# LiDAR Quality Assessment Report

AR\_FEMA-Bayou-Meto\_2012

FEMA VI - Bayou Meto

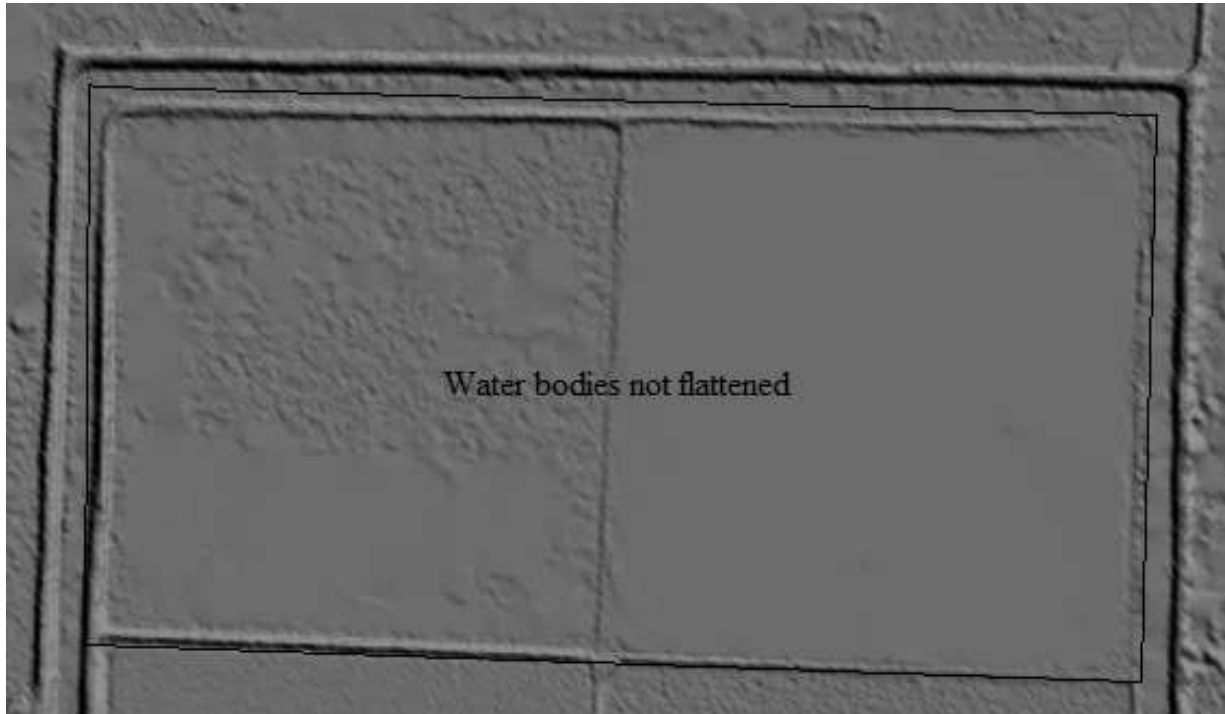
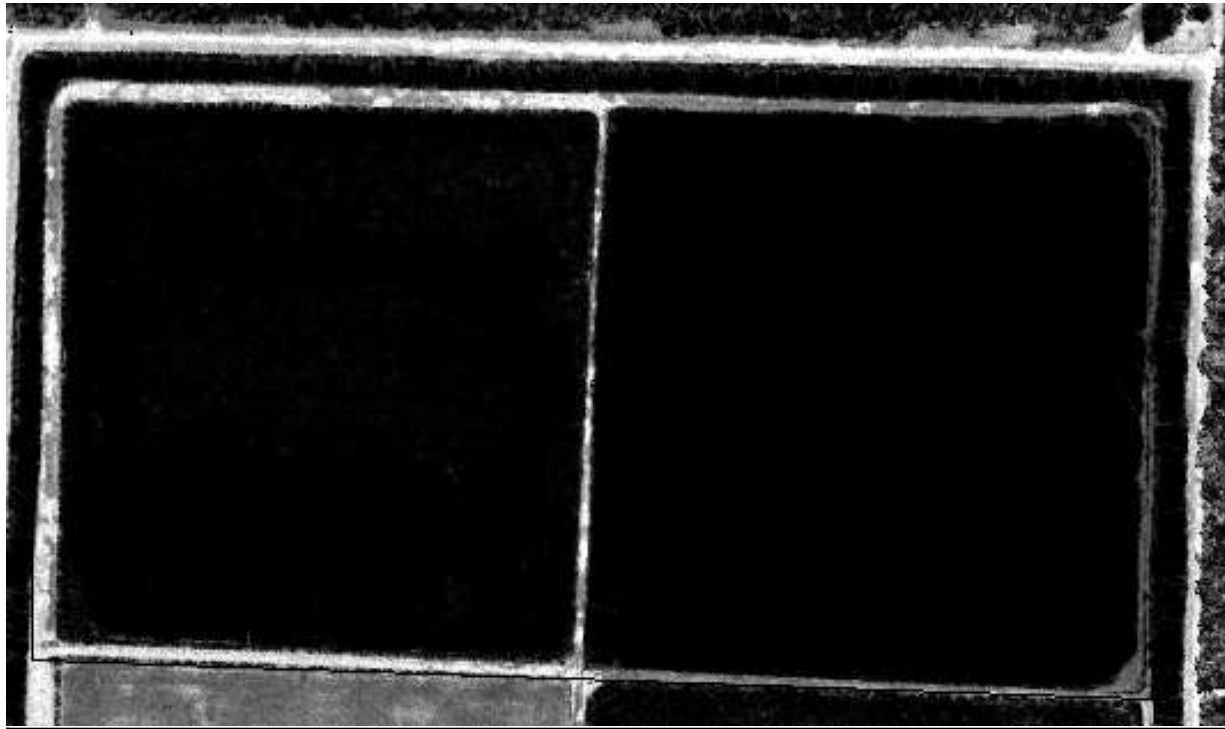
The above error is an example. There are several of these in the dataset, all marked in the errors shapefile provided with this report. There are water bodies that are greater than 2.0 acres in area that are not flattened. These were determined to be water bodies looking at both the DEM and the intensity imagery. This first image shows the hillshaded DEM, the second will show the intensity image.

Same area as above, but using intensity imagery instead of the DEM.

01/22/2012: Requested fixes on water bodies have been made. It should be noted that there are a great deal of features in this dataset that appear to be water, however upon closer inspection, may actually be swamp or wetlands. These have remained unflattened.

vegetation classified as bare ea\*

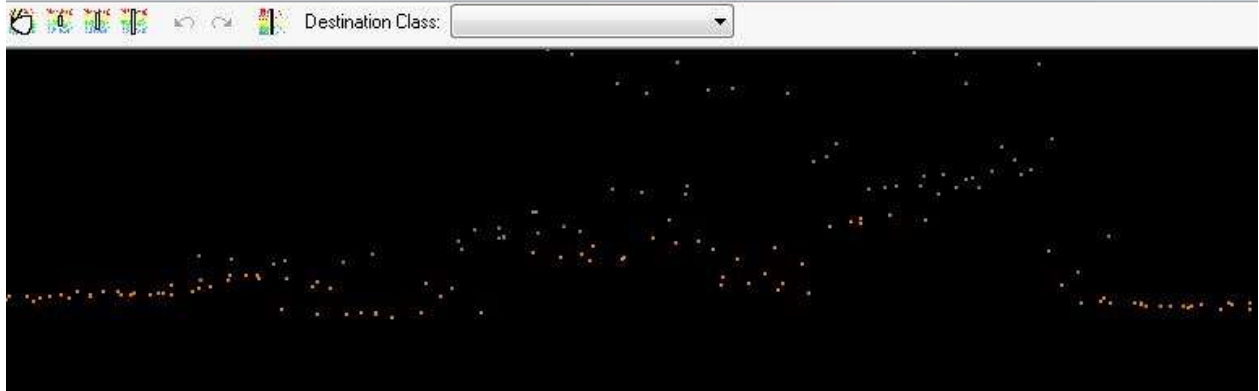
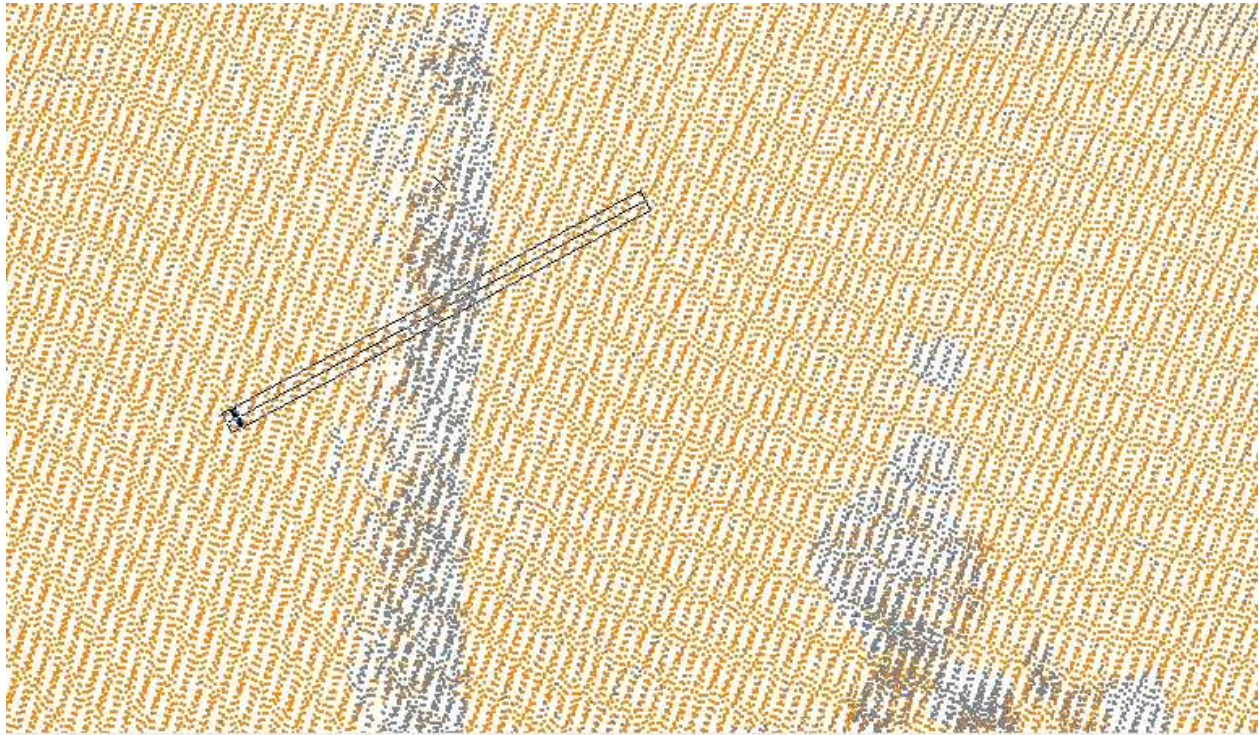
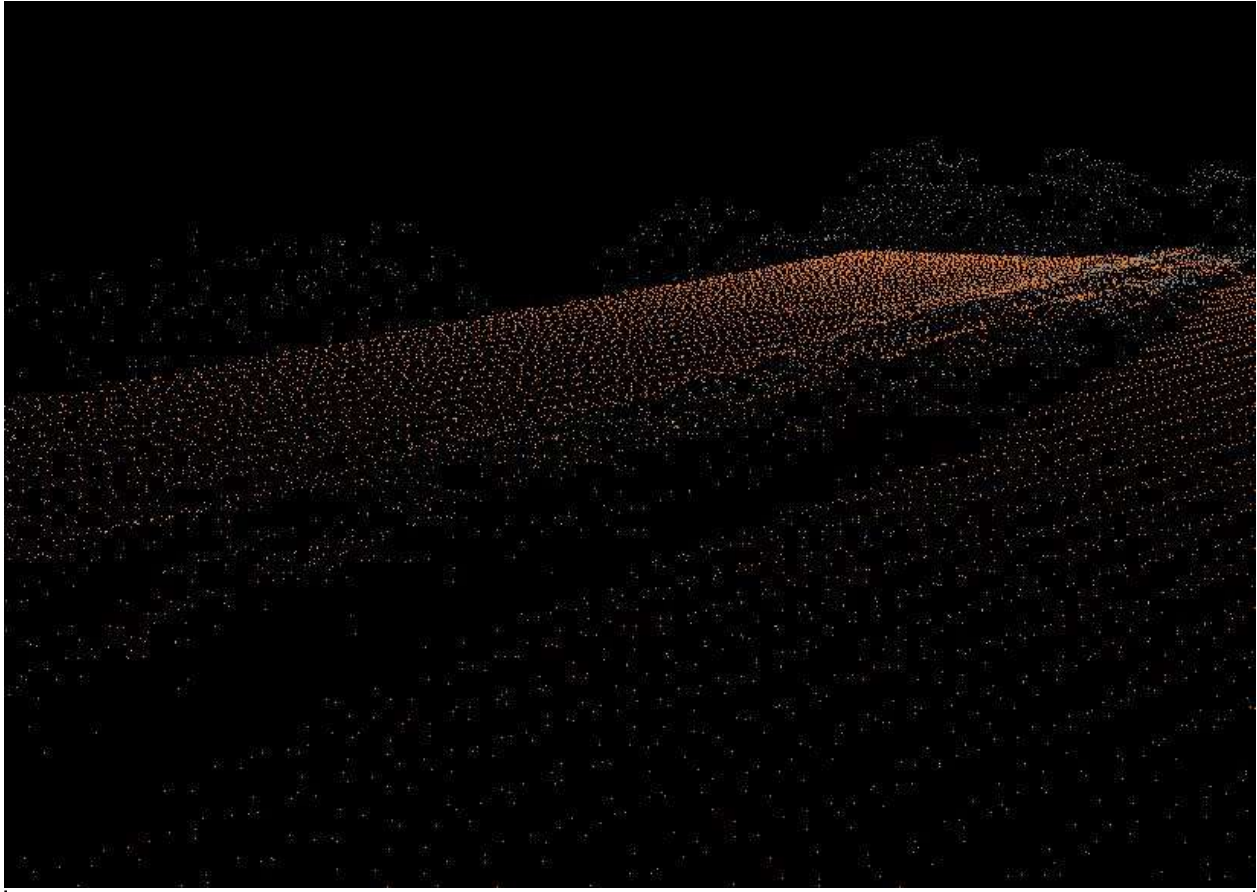
There were two instances where points that appear to be non bare earth were classified as ground, and therefore are included in the DEM. The above image shows an example of the affected area in the DEM, and the subsequent images show the areas in the LAS files.

This is the same area as above, but in the LAS files as a profile view.

Same area as in previous images, as a 3D view.

01/22/2012: Vegetation has been removed from DEM. Project is accepted.

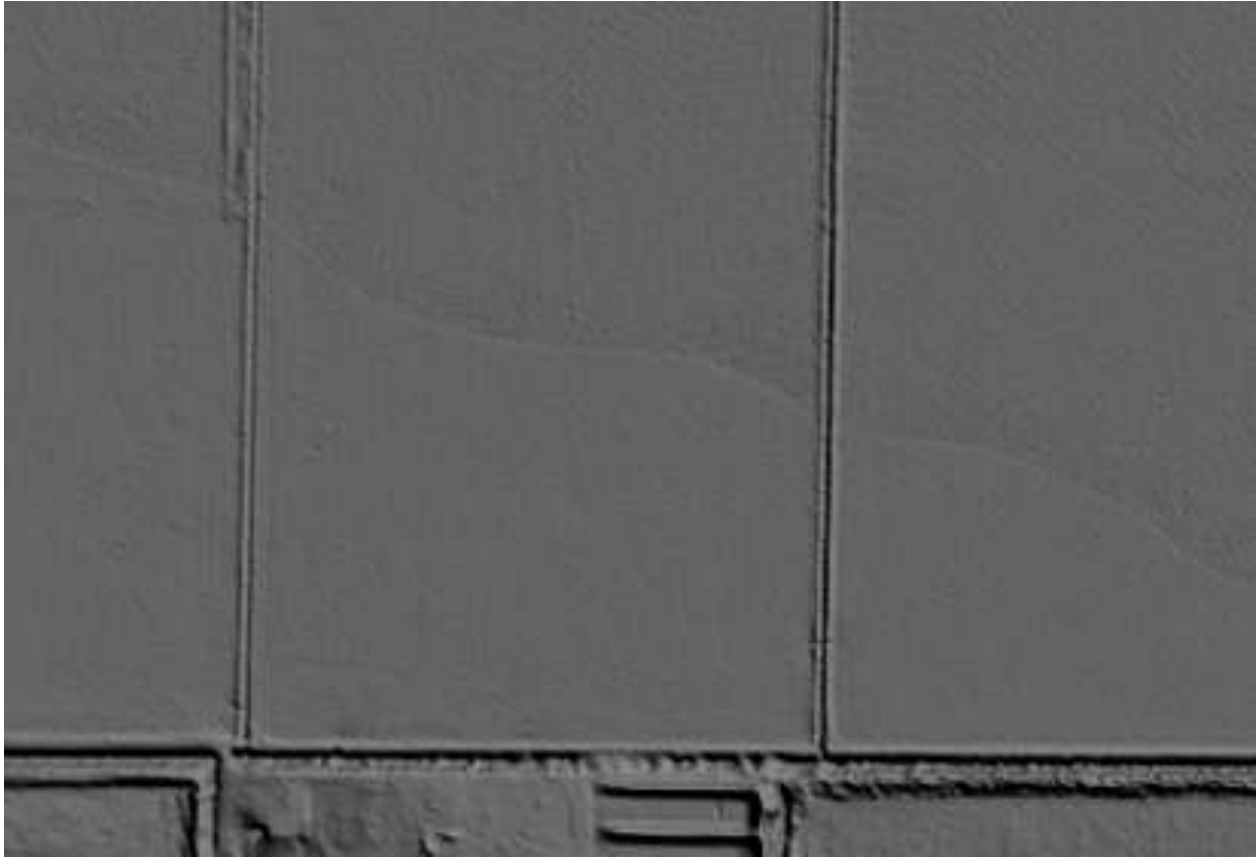
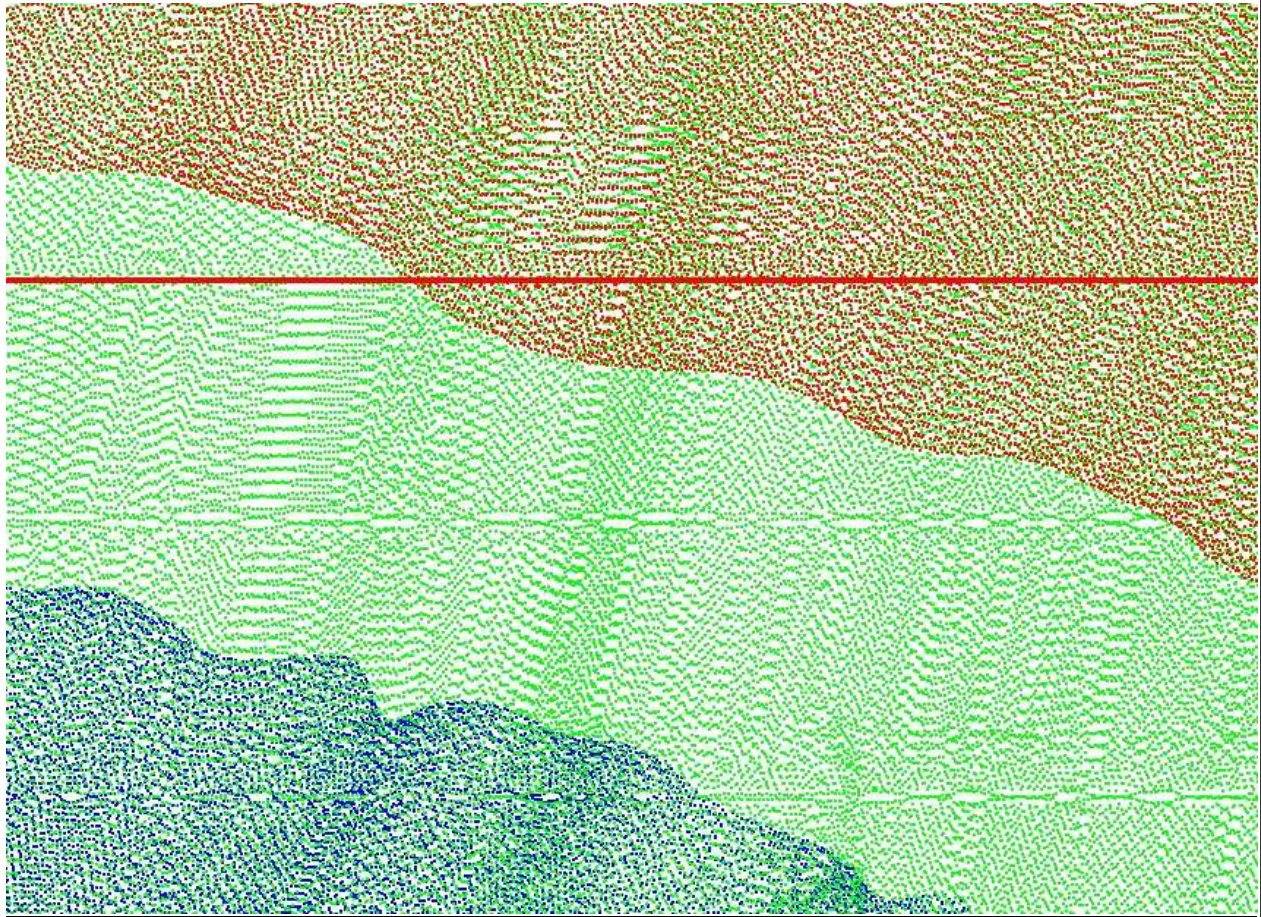
The next example is not an error, but an item worth noting. In areas of overlap coverage between swaths, the boundaries of the overlap appear in the DEM. This is not affecting the quality of the data and has a negligible affect on the elevation. The above image shows the DEM, the subsequent images the same area in the LAS files.

Same area but in the LAS files, symbolizing the points by point source ID.

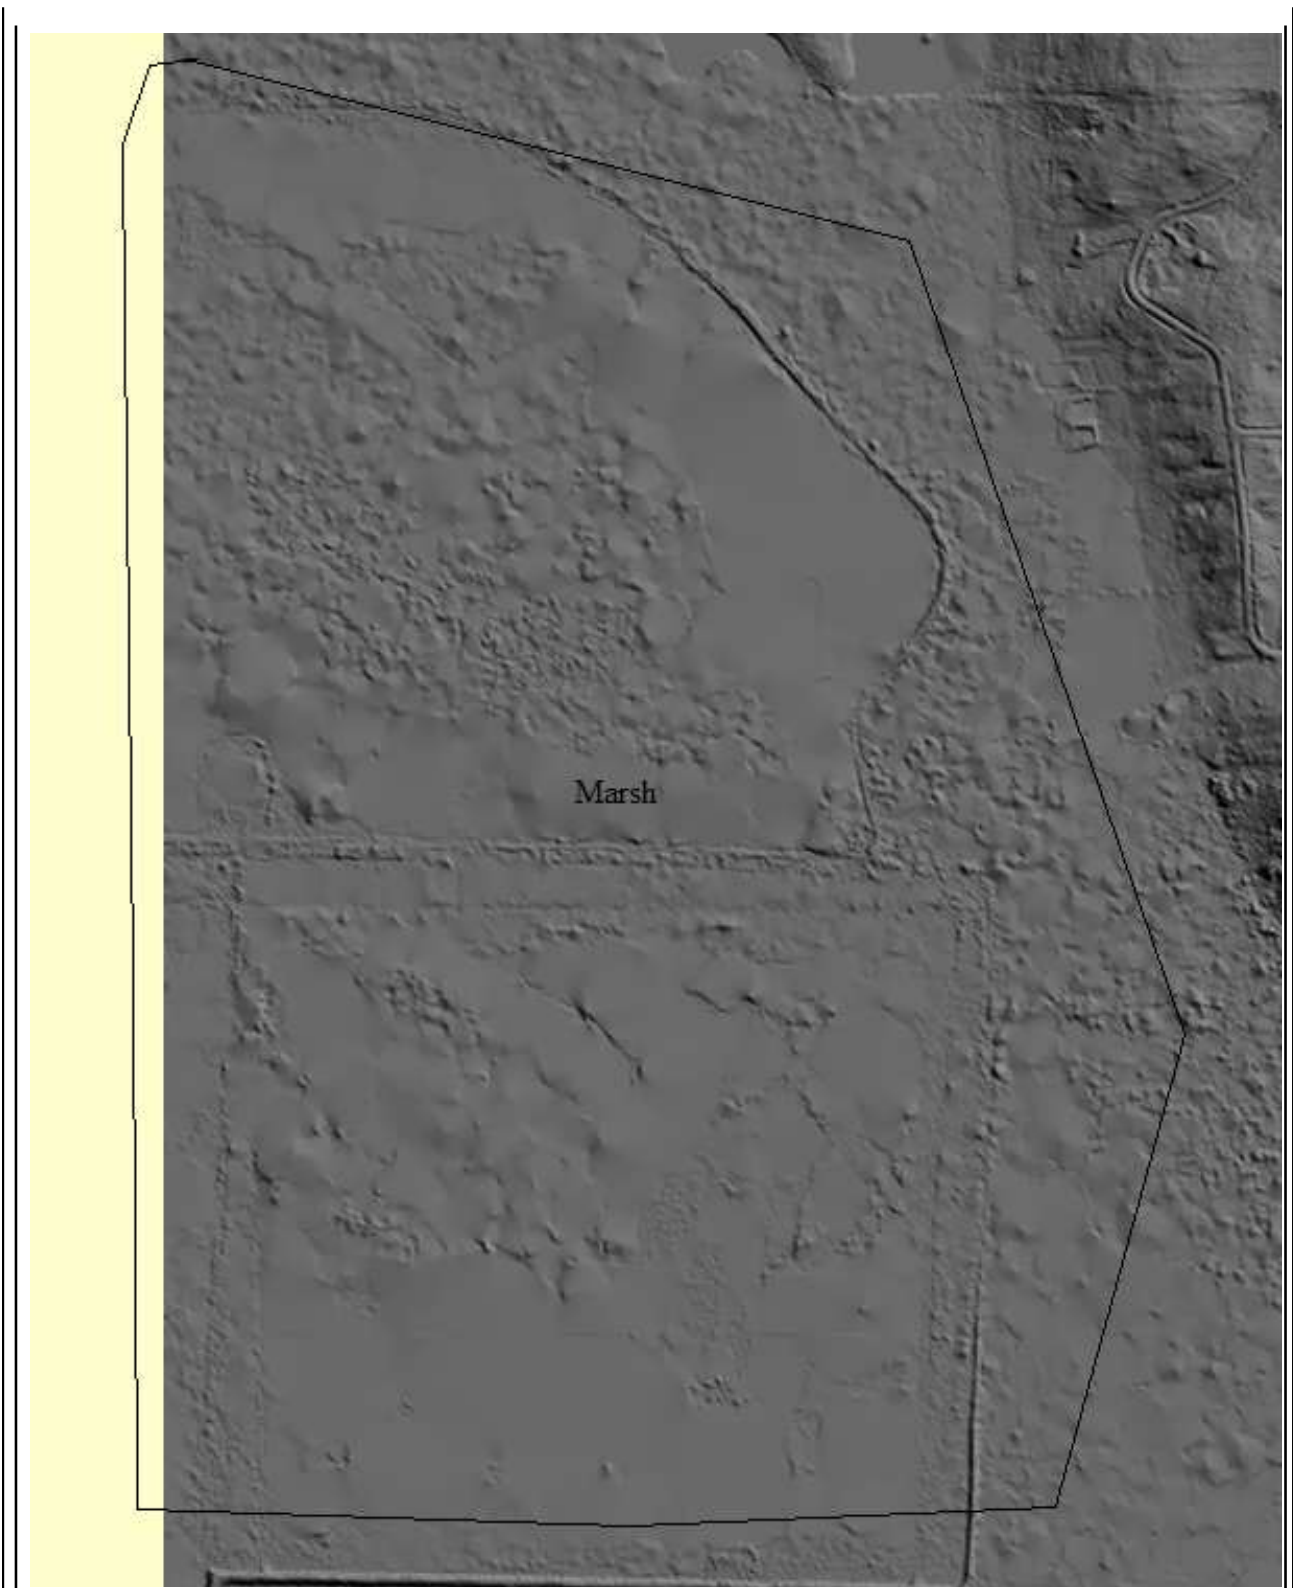
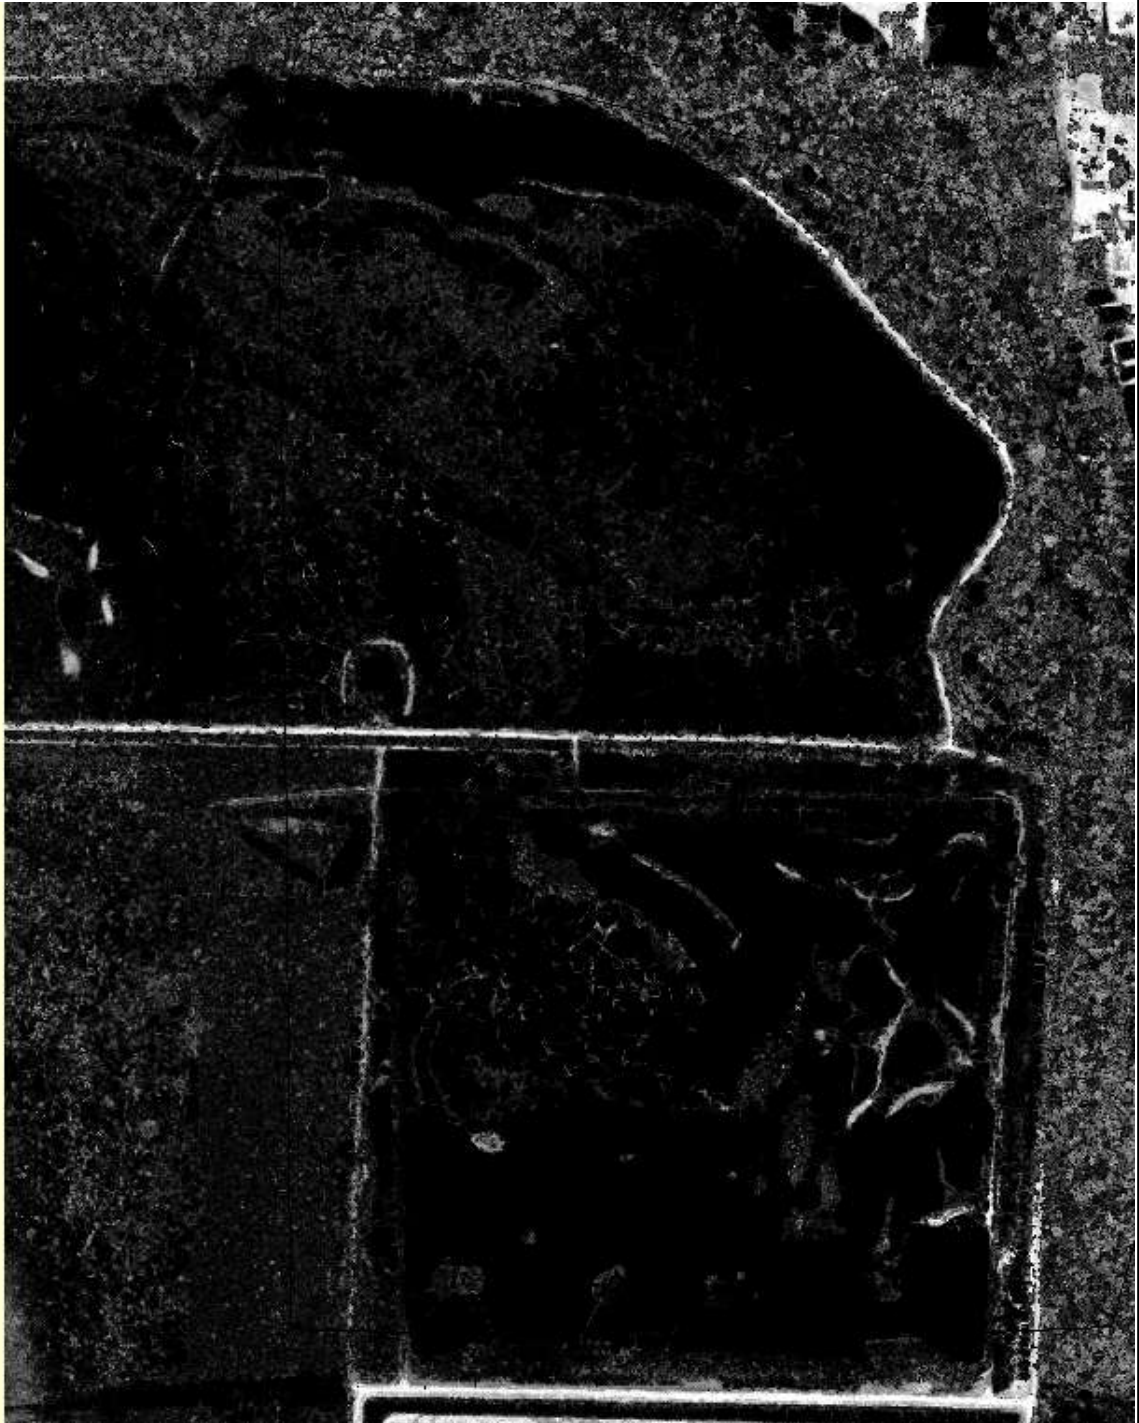
The area of interest contains a substantial amount of marsh land cover types. For marshes, there is some tinning that exists in the DEM, however, because there is a large amount of ground points in these areas, these regions have not been hydro-flattened. This is not an error, and will be accepted by the NGTOC. The above image shows marsh in the DEM, and the next image will show the same area using intensity imagery.

Same area as above, only using intensity imagery instead of the DEM.
